**ISSUE:** Appeal of a decision of the Board of Architectural Review approving a Certificate of Appropriateness for alterations in the Old and Historic District (OHAD) with conditions

**APPLICANT:** 910 King Street, LLC

**LOCATION:** Old and Historic Alexandria District  
910 King Street

Figure 2B: Proposed entry door and railings

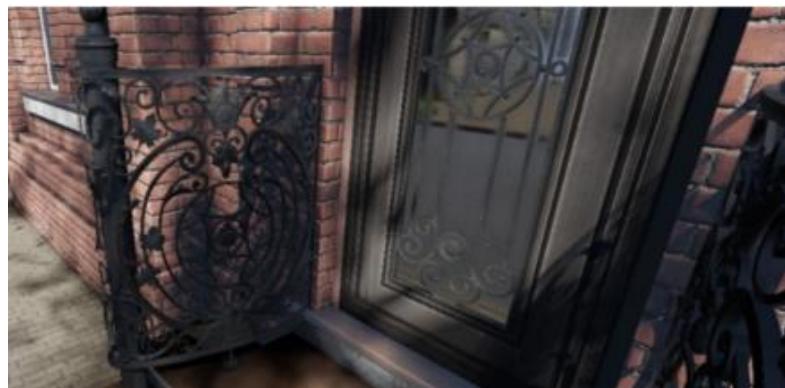
The applicant is proposing to install a new wood and glass door with decorative metal work at the exterior face of the building and to install new handrails on either side of the stone steps (Figure 2). From a site inspection, it appears that the glazing in the existing transom appears to be cylinder glass that may be original to this elevation, the existing door is not historic. Under the existing configuration, the entry door is recessed from the front elevation but under the proposal, the entry door will be in line with the existing transom at the face of the building.

The applicant is proposing to install decorative railings on either side of the main entry steps (Figure 3). While railings were not originally installed on many historic buildings, the Board has often allowed their installation to address safety concerns when designed to be compatible with the style of the existing building.

The applicant is proposing to install a new wood and glass door with decorative metal work at the exterior face of the building and to install new handrails on either side of the stone steps. From a site inspection, it appears that the glazing in the existing transom appears to be cylinder glass that may be original to this elevation, the existing door is not historic. Under the existing configuration, the entry door is recessed from the front elevation but under the proposal, the entry door will be in line with the existing transom at the face of the building. Staff has no issue with the relocation of the entry door or the installation of a wood and glass door as this is consistent with other historic building entries in the district. A primary tenet of historic preservation is that any building modifications that are made should not change the historic character of a building or create a combination of styles within the same structure. The design of the proposed metal scrollwork is too decorative and is inconsistent with the style of the building and staff suggests that the applicant work with staff to simplify this design. Staff also recommends that the historic transom be retained and any new metalwork be applied such that it can be removed without damaging the transom.

The applicant is proposing to install railings on either side of the main entry steps. While railings were not originally installed on many historic buildings, the Board has often allowed their installation to address safety concerns. The *Design Guidelines* state that “Stoops, steps, and railings should be appropriate to the historic style of the structure. For example, turned wood balusters and newel posts on entrance steps are a common feature of Victorian architecture. Decorative cast iron steps and railings are also a common feature of Victorian buildings.” As with the design for the scrollwork on the door, the design for the railings is not consistent with the style of the building and detracts from the historic character of the structure. Staff recommends that the applicant work with staff to simplify the design and to determine an appropriate attachment method for new railings that will not damage the existing stone steps.

While this proposal does not change the arrangement of the building on the site, the proposed modifications to the building entry will have a significant impact on the streetscape. As noted above, the proposed railings at the entry steps feature a decorative pattern that derives some features from metalwork found throughout the district but in a very dense pattern that is not consistent with the architectural style of the building. While the *Design Guidelines* acknowledge that decorative metal railings are a feature of Victorian architecture, the proposed pattern exceeds the level of complexity that is appropriate for this building. Staff recommends that the applicant work with staff to simplify the design and to determine an appropriate attachment method for new railings that will not damage the existing stone steps.

Ms. Zandian stated that any new exterior railings should be in the Greek Revival style to match the building.

Ms. del Ninno pointed out that as shown in the renderings, the height of the exterior railings appears to be in excess of what is required by Code. The applicant stated that the final design would match Code requirements.

3. The applicant will work with staff to simplify the design of the metal scrollwork at the entry door and transom and the existing transom be retained and any metal work applied to the transom be easily removable.	<u>Modify</u> – Replace “simplify the design” to “match the Victorian style of the building”, per Section 10-105(A)(2)(a)

4. The applicant will work with staff to simplify the design of the railings at the building entry to be consistent with the style of the building.	<u>Modify</u> – Replace “simplify the design” to “match the Victorian style of the building”, per Section 10-105(A)(2)(a)

Figure 4: Decorative metalwork on top of knee wall above projecting bay

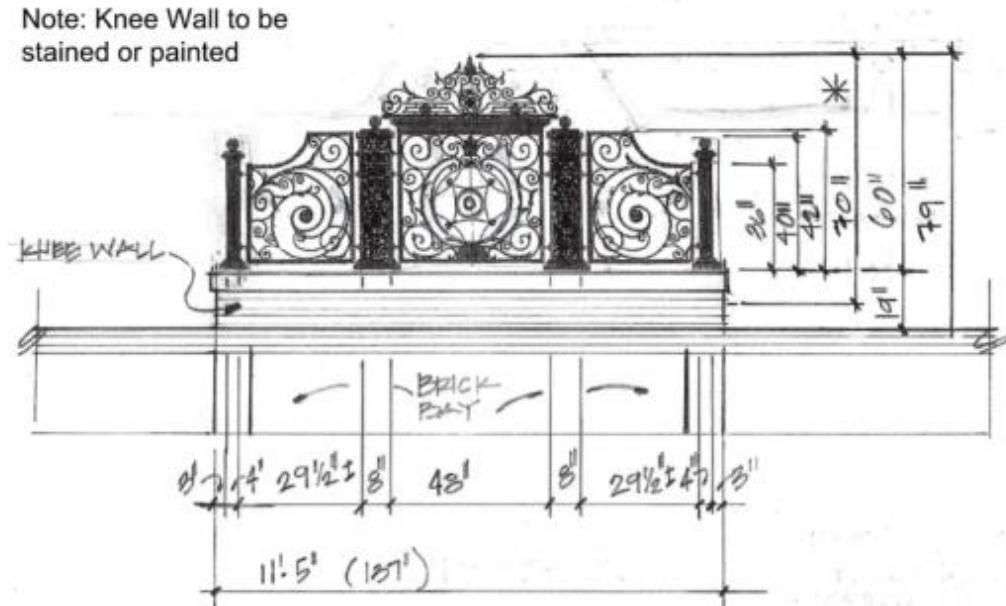
The applicant is proposing to install decorative metalwork attached to the top of the knee wall located above the projecting bay extending above the roof (Figure 4). In previous reviews of this proposal, Board members expressed concern with the size and design of this metalwork.

As noted above, the applicant is proposing to install decorative metalwork attached to the top of the knee wall located above the projecting bay extending above the roof. In previous reviews of this proposal, staff and board members have expressed concern with the size and design of this metalwork.

Staff appreciates that elements of the design have been taken from the decorative brickwork on the front of the building, however the size and complexity of this element overpower the historic building. As noted in the submission material, the building across King Street from the subject property has many of the same historic details and in many ways can be considered a sibling to this building. At the top of the projecting bay on this building is a decorative slate roof with a simple metal embellishment (Figure 7). This section of roof is similar to the masonry knee wall at the top of the bay on 910 King Street. Staff finds that the metalwork proposed for the top of the knee wall is incompatible with the design of the historic building and recommends that the applicant work with staff to design a metal embellishment of approximately the same scale and complexity as the one on 913 King Street as shown in Figure 7.

5. The applicant will work with staff on the design of the rooftop metalwork embellishment so that it is of a size and complexity similar to the one on the roof of 913 King Street.	<u>Affirm</u> – The proposed metalwork at the top of the knee wall is incompatible with the design of the building, per Section 10-105(A)(2)(a)

Figure 5: Proposed building sign at top of projecting bay

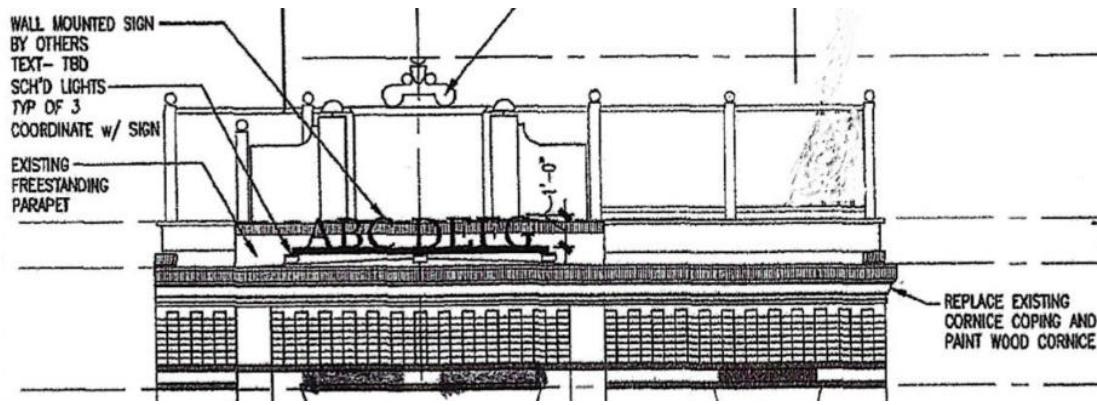
The applicant is proposing a building sign that is mounted to the face of the knee wall above the projecting bay (Figure 5). The letters on this sign will be approximately 2' tall.

The applicant is proposing a building sign that is mounted to the face of the knee wall above the projecting bay. The letters on this sign will be approximately 2' tall. Staff finds that the installation of a sign in this location will detract from the architectural character of the building. Signage at the first floor of a retail establishment is expected and is a part of the pedestrian scale of the neighboring structures. Locating a sign at the upper portion of the projecting bay changes the character of the bay and detracts from its historic character. Staff recommends that the proposed rooftop signage and associated lighting be denied.

6. The proposed rooftop signage and lights be denied.	<u>Affirm</u> – Prominent signage at this location is incompatible with the design of the building and will detract from the architectural character, per Section 10-105(A)(2)(b)
